Q-374

SVE BULLETIN

E-SERIES & F-650/750 - 4G MODEM DELETE

MODEL(S) AFFECTED:
2026MY E-Series Stripped Chassis and Cutaway
2026MY F-650/F-750 Chassis Cab

2026MY E-SERIES STRIPPED CHASSIS

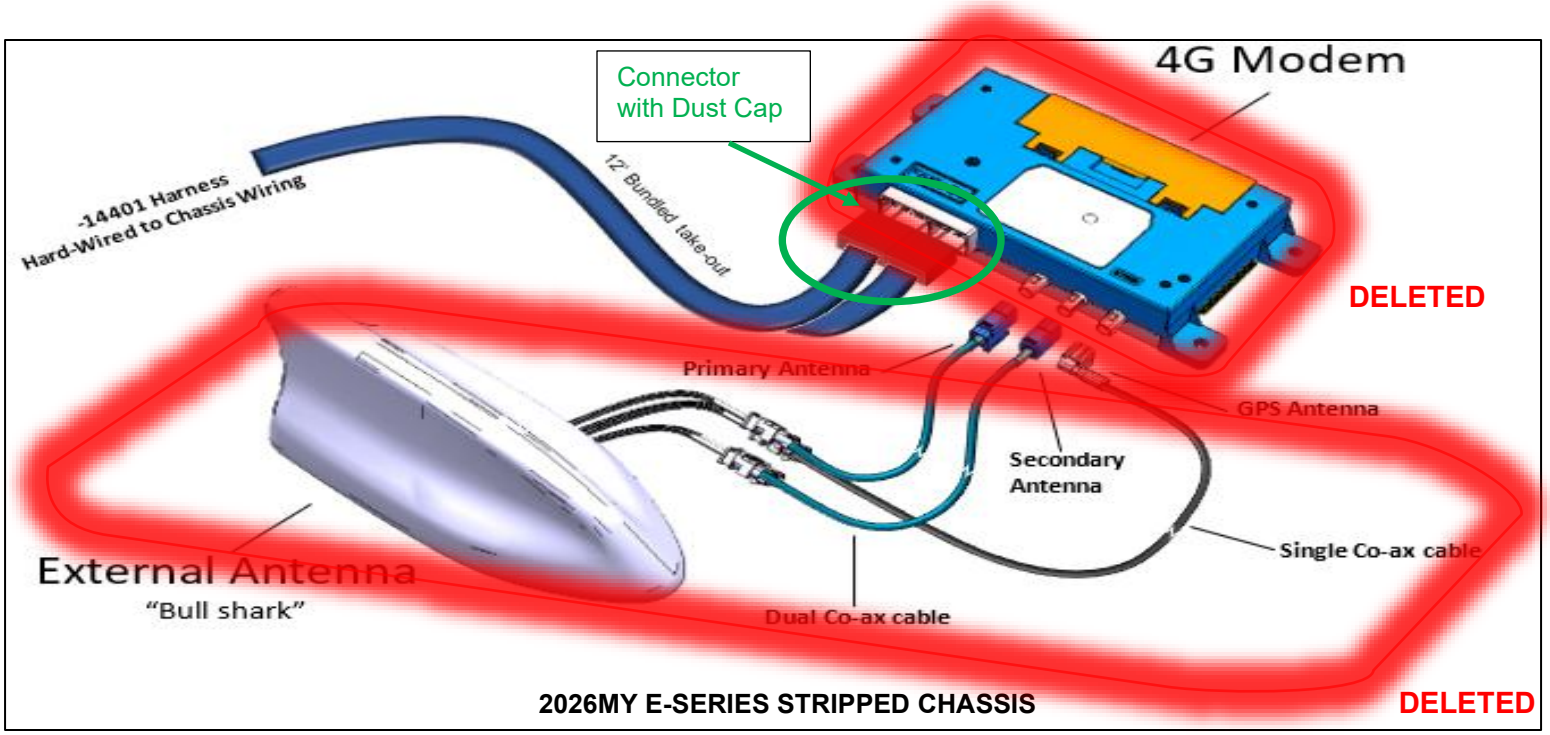
The following components are deleted and will **not** be included in the vehicle content for TCU-4G Modem

- Shark Fin Antenna
- Dual Coaxial Cables
- Antenna Cable

(Note: 14401 wiring harness will remain, and connector dust cap will be included.)

2026MY E-SERIES CUTAWAY

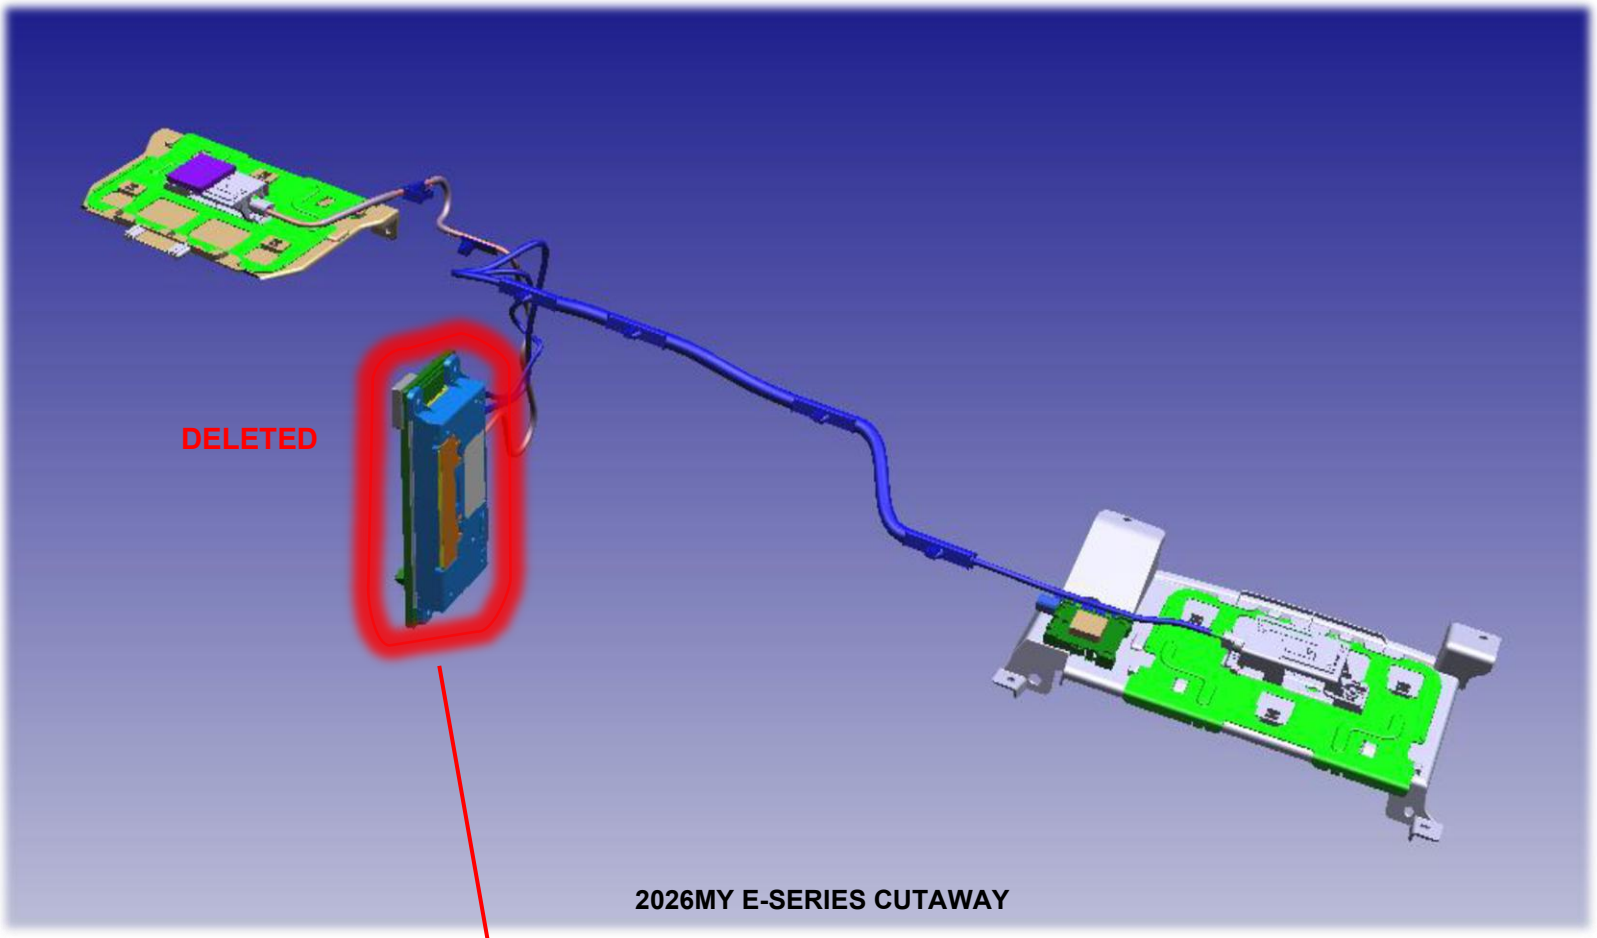
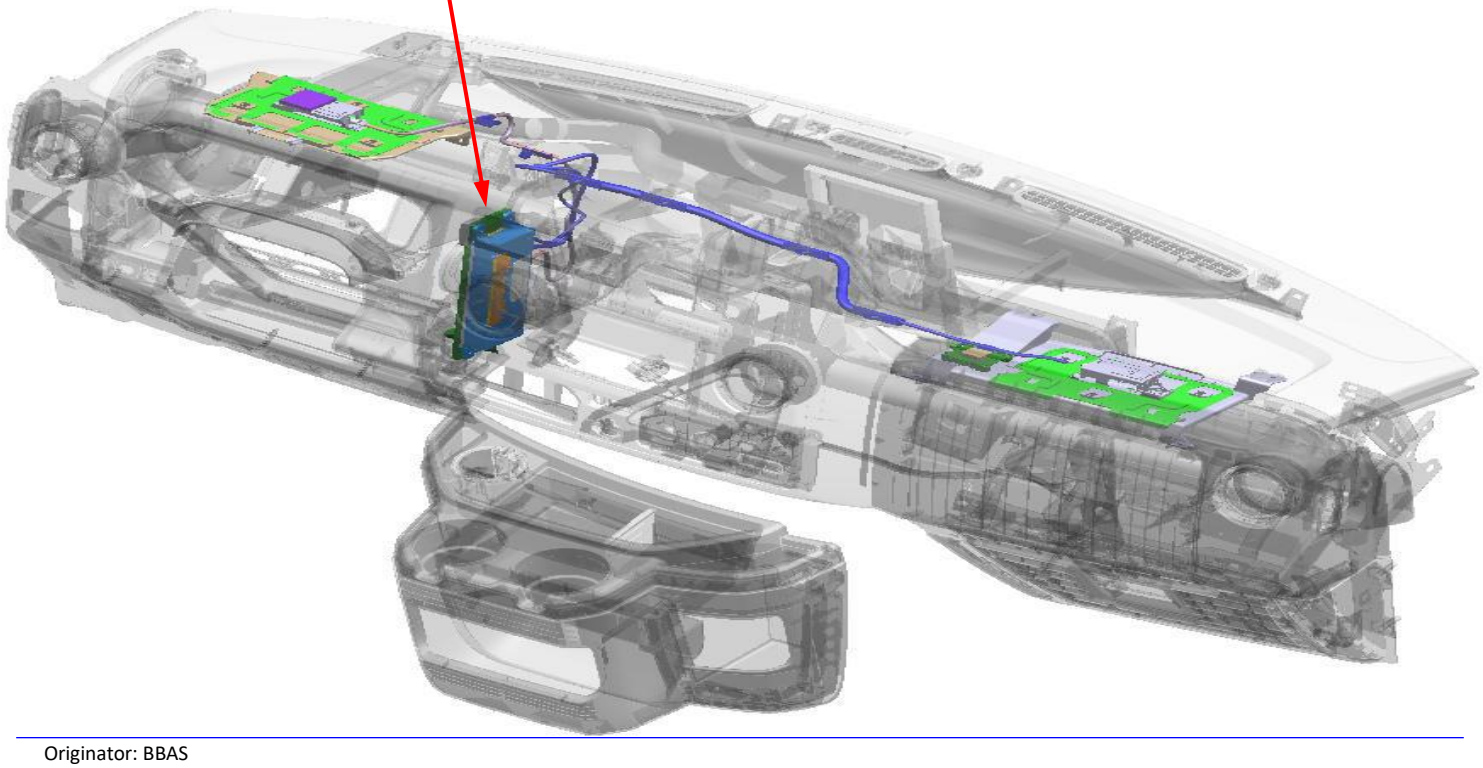
The following components are deleted and will **not** be included in the vehicle content:

- 4G Modem

(Note:14401 wiring harness will remain, and connector dust cap will be included. Antenna, Coaxial Cables, Antenna Cable will be included in vehicle content.)

2026MY F-650/750

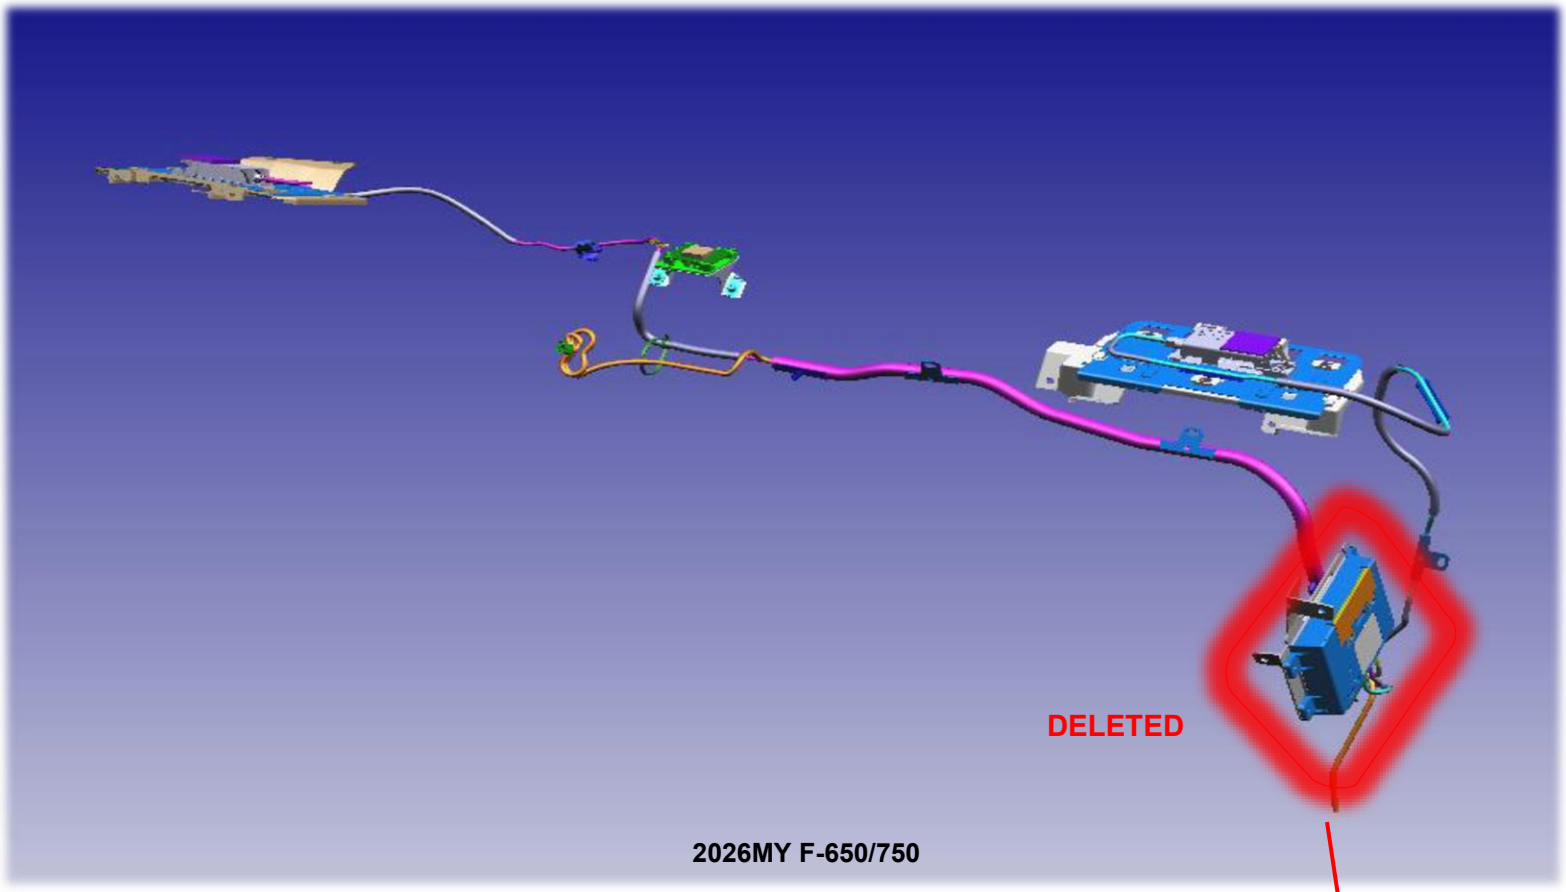
The following components are deleted and will **not** be included in the vehicle content:

- 4G Modem

(Note: 14401 wiring harness will remain, and connector dust cap will be included. Antenna, Coaxial Cables, Antenna Cable will be included in vehicle content.)
